Arlington Zoning Board of Appeals

4. **Thorndike Place: Discussion of Architectural and Urban Design Aspects of Project Submission.**
5. **Thorndike Place - Updated Documents from Applicant**
6. **Thorndike Place - Public Comments**
7. **Thorndike Place - Previous Correspondence Received**
8. **Thorndike Place - New Documents**

Type	File Name	Description
▢ Reference Material	2021-01-18_Stormwater_Report.pdf	2021-01-18 Stormwater Report
▢ Reference Material	2021-01-22_Response_to_Stormwater_Peer_Review-Thorndike_Place.pdf	2021-01-22 Response to Stormwater Peer Review-Thorndike Place
▢ Reference Material	FIA_Thorndike_Place_(00186746xBC4F6).pdf	FIA_Thorndike Place (00186746xBC4F6)
▢ Reference Material	2021-01-21_Revised_Plan_Sheets.pdf	2021-01-21 Revised Plan Sheets
▢ Reference Material	2021-01-25_Response_to_BETA_Traffic-Thorndike_Place_with_Attachment.pdf	2021-01-25 Response to BETA Traffic-Thorndike Place with Attachment
▢ Reference Material	Thorndike_Place_Revised_Wetland_Delineation_Memo_2021-01-18_with_Field_Data_Forms.pdf	Thorndike Place Revised Wetland Delineation Memo_2021-01-18 with Field Data Forms

SHEET C-200

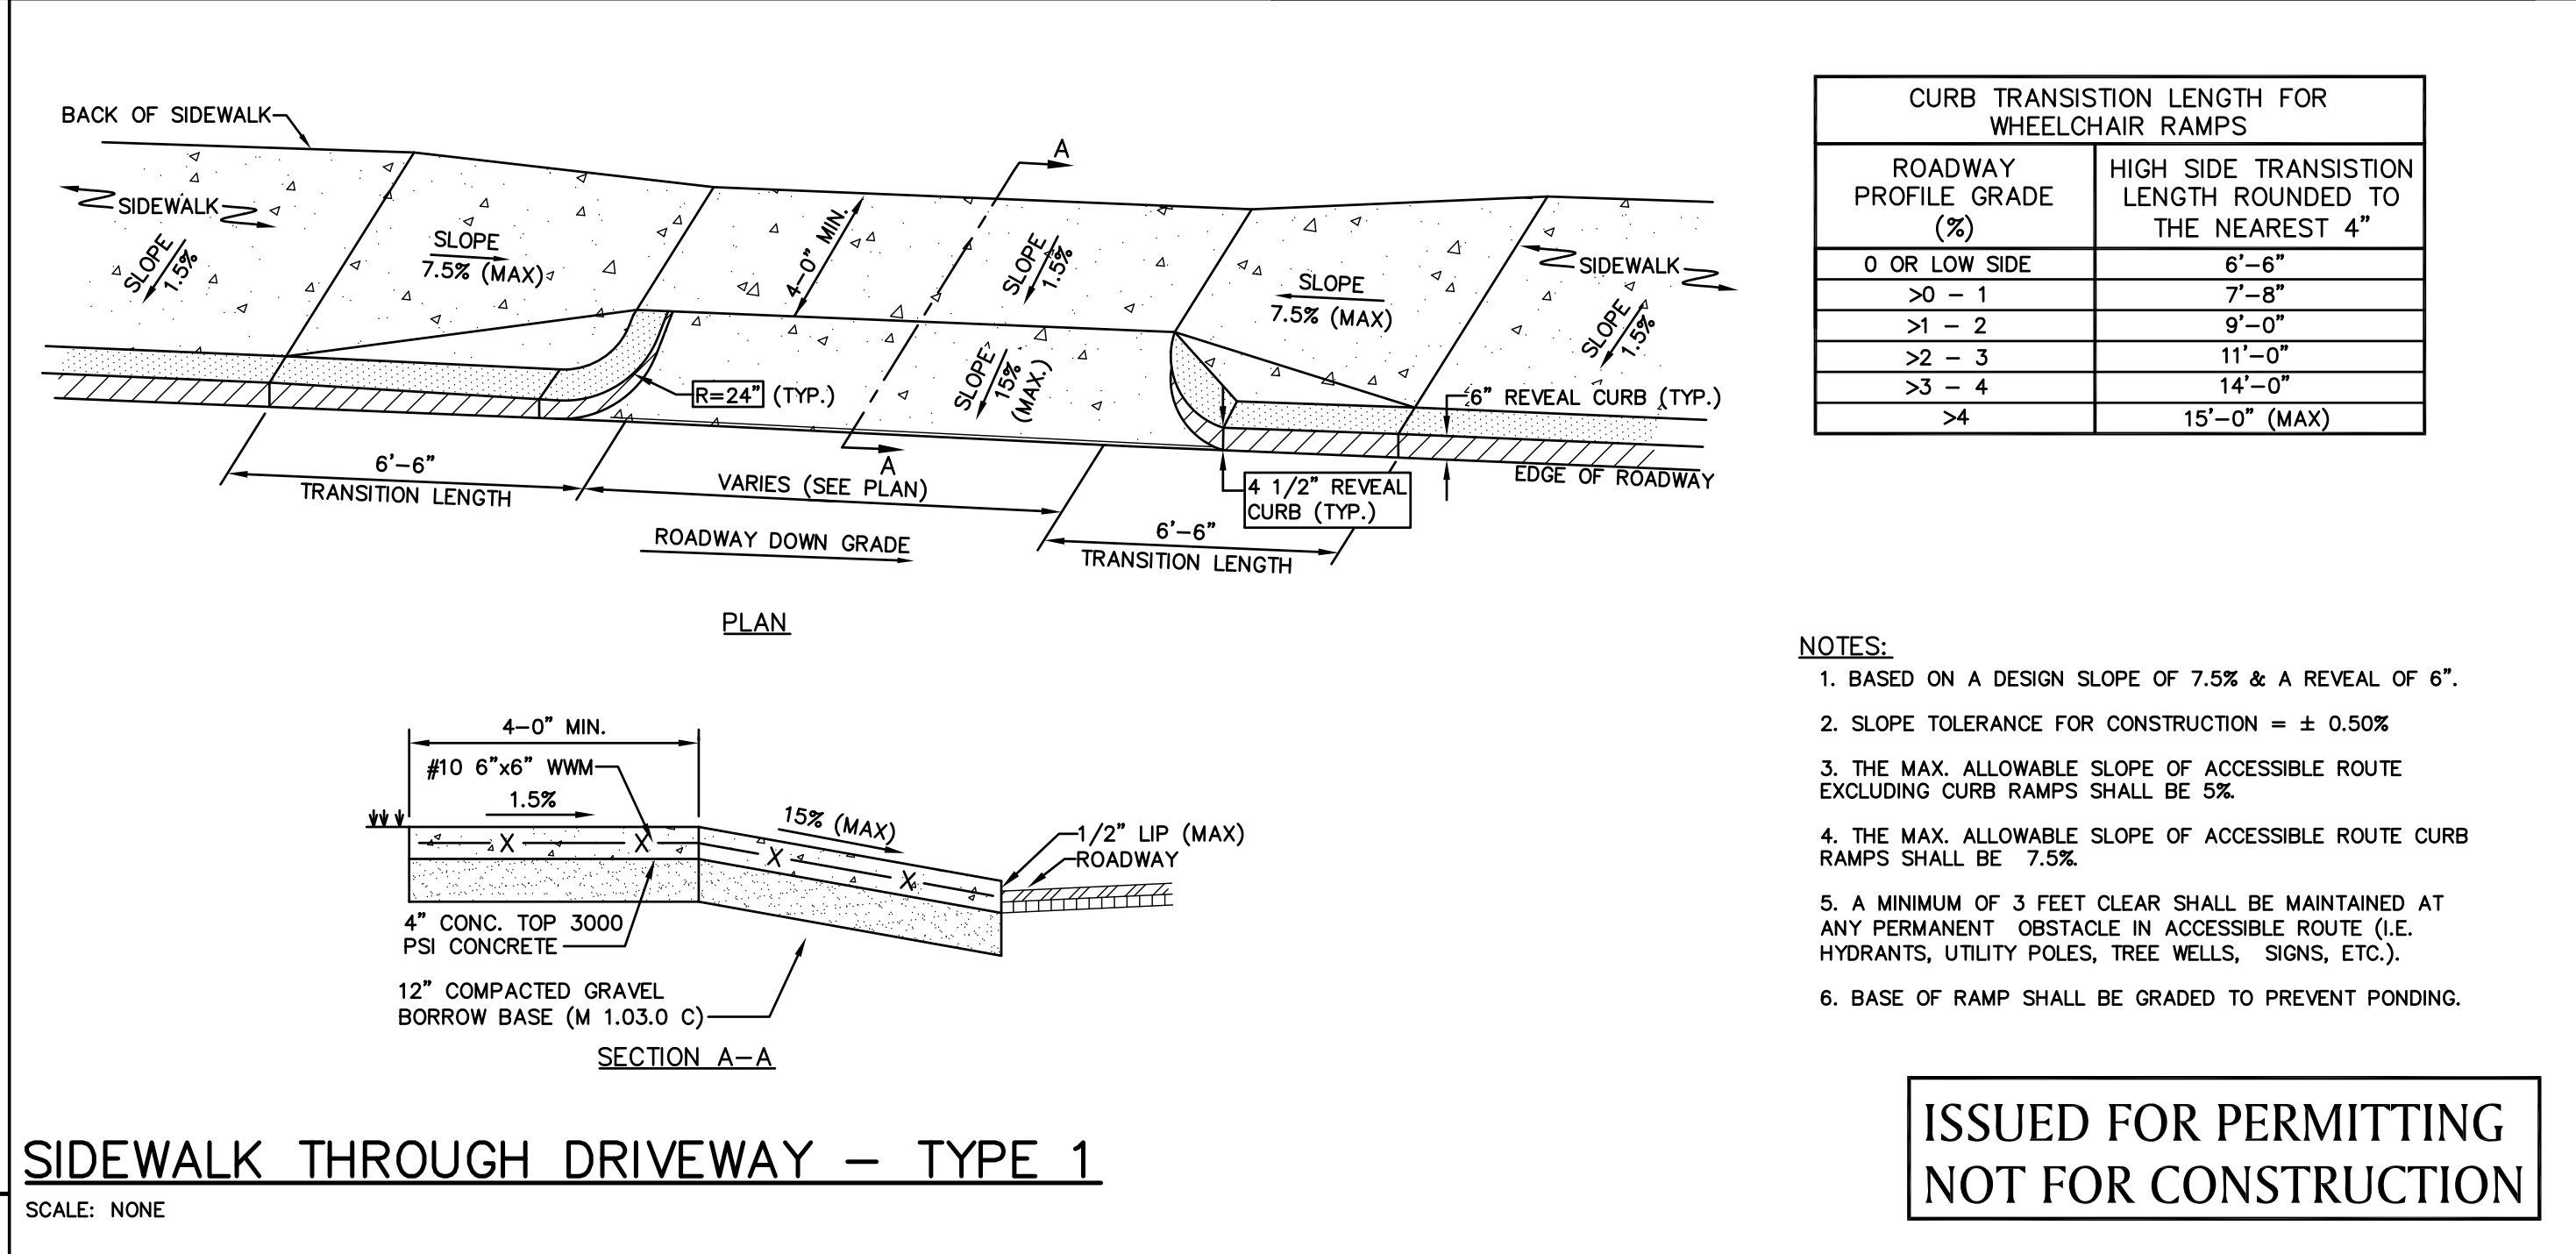
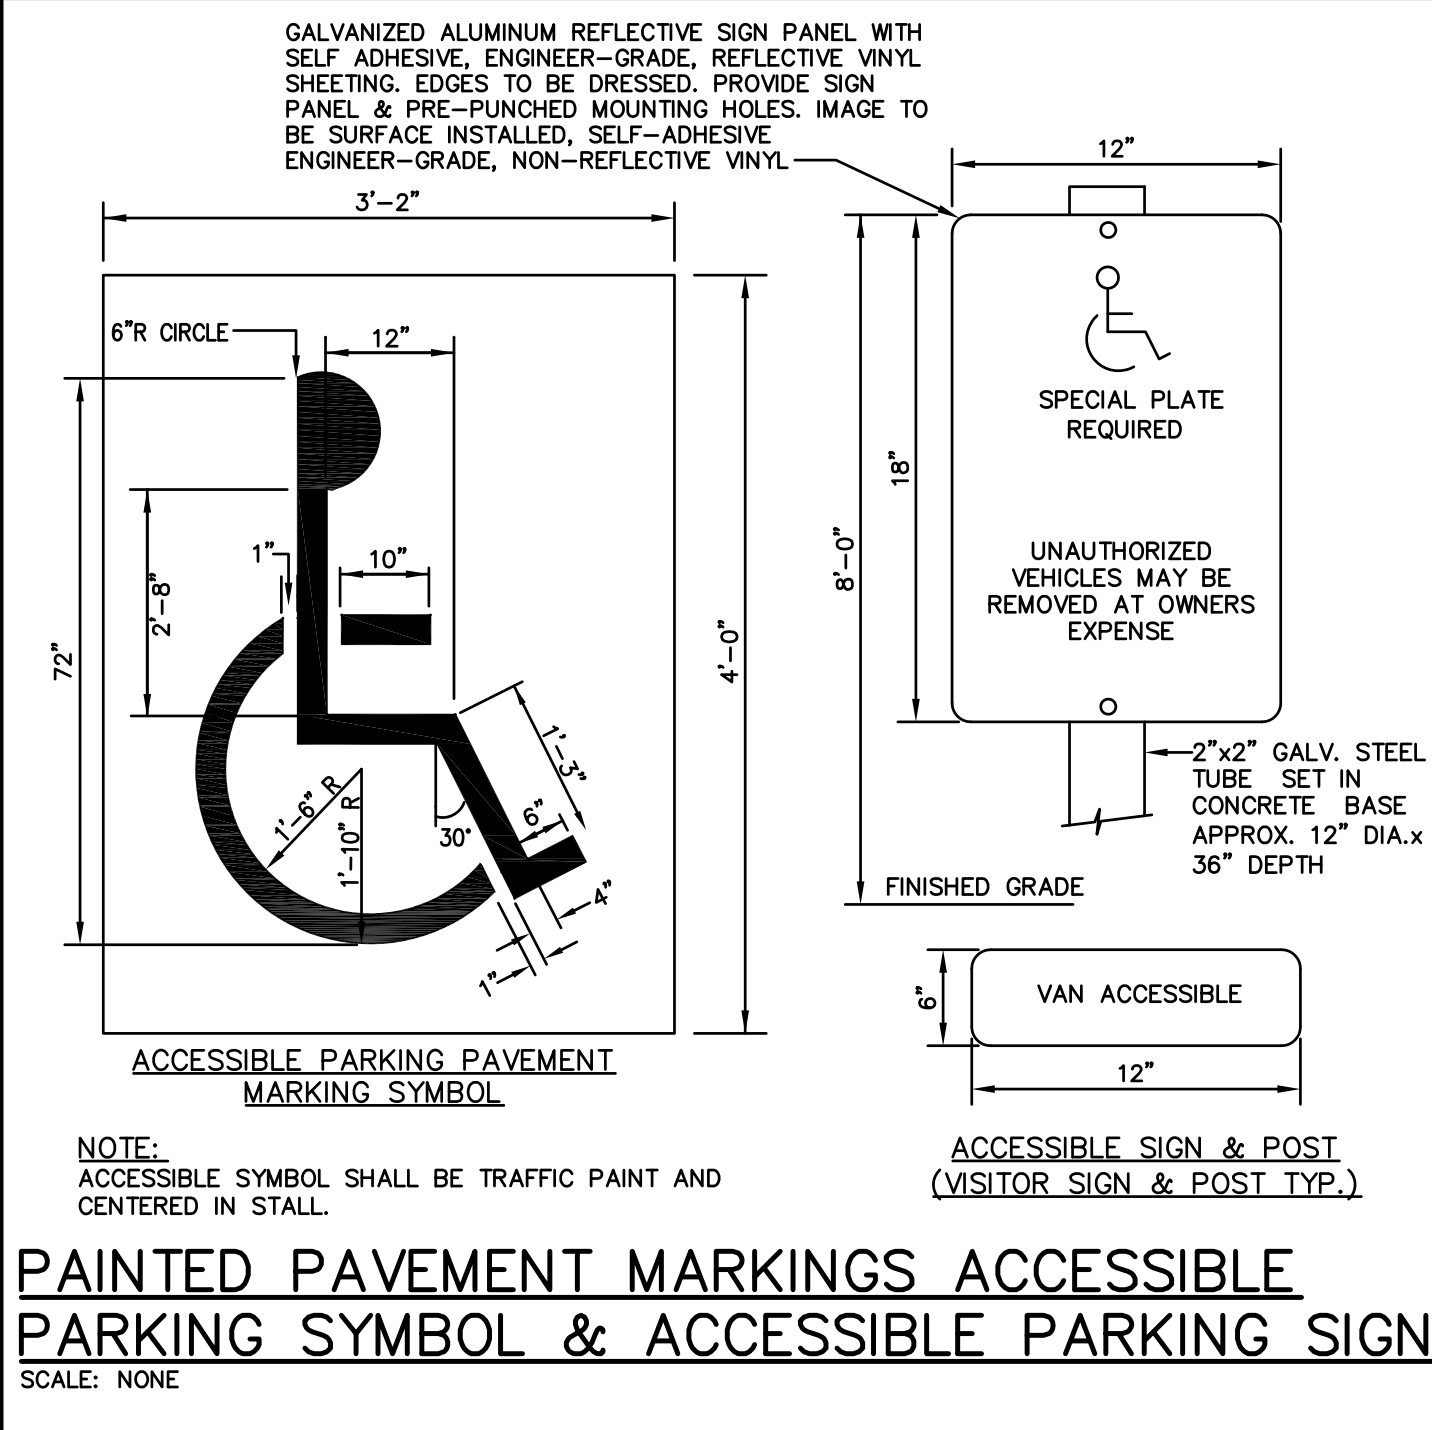
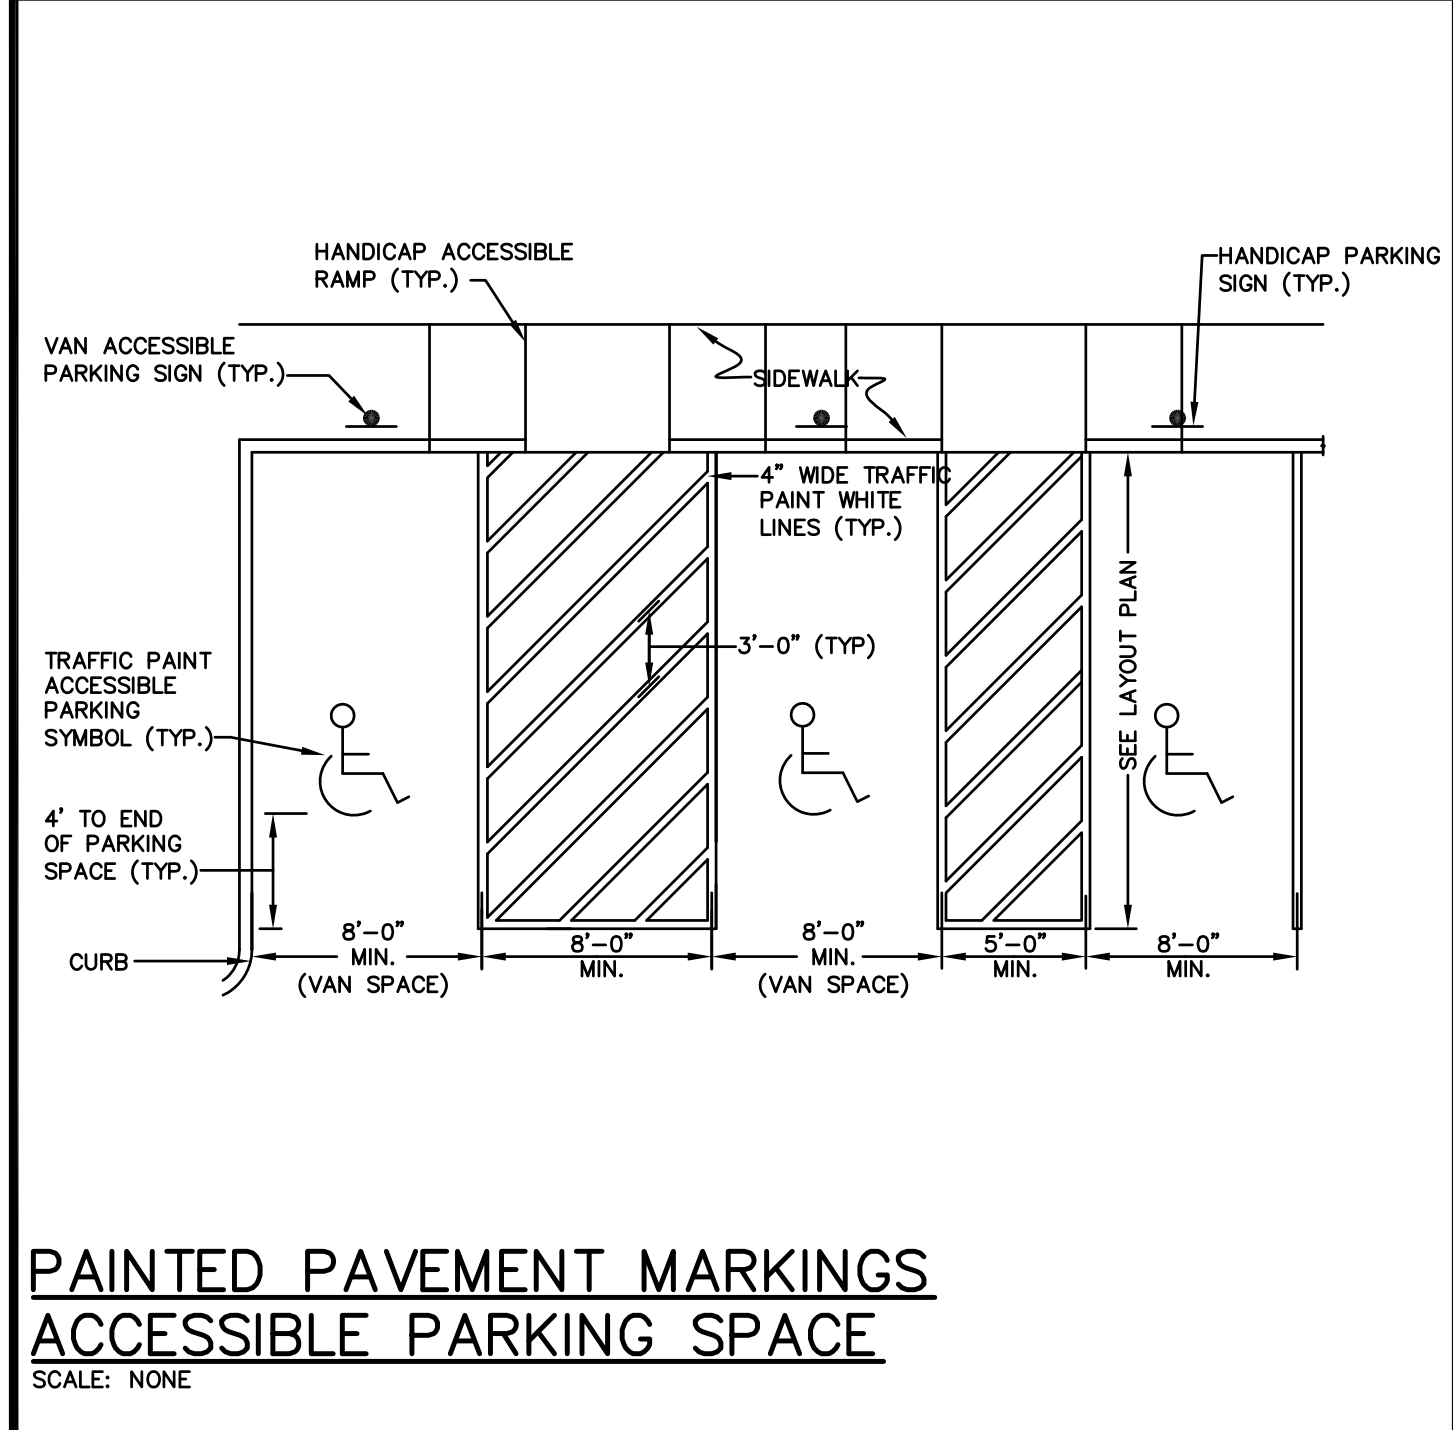
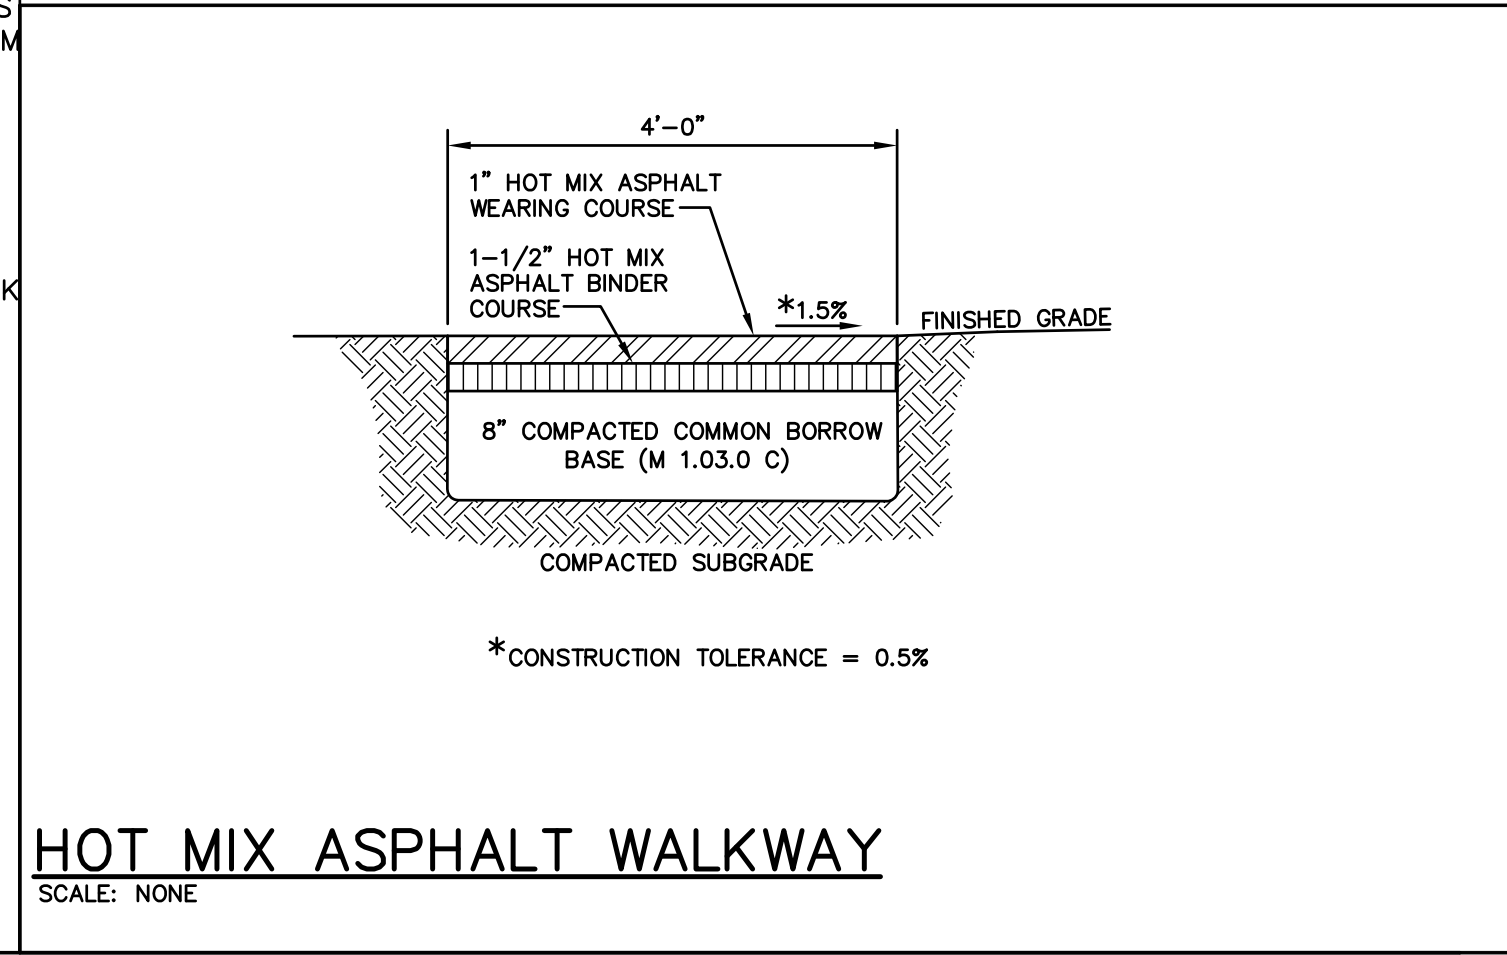
9. Civil and Landscape Details (sheet 1) – The applicant has provided a Silt fence with Haybales erosion control barrier detail.

Response: The perimeter erosion controls have been revised as recommended and are shown on the enclosed revised Site Preparation Plan and Grading & Drainage Plan. A detail of the 18-inch diameter compost-filled silt sock with silt fence has been added to the enclosed Civil and Landscape Details (Sheet C-200).
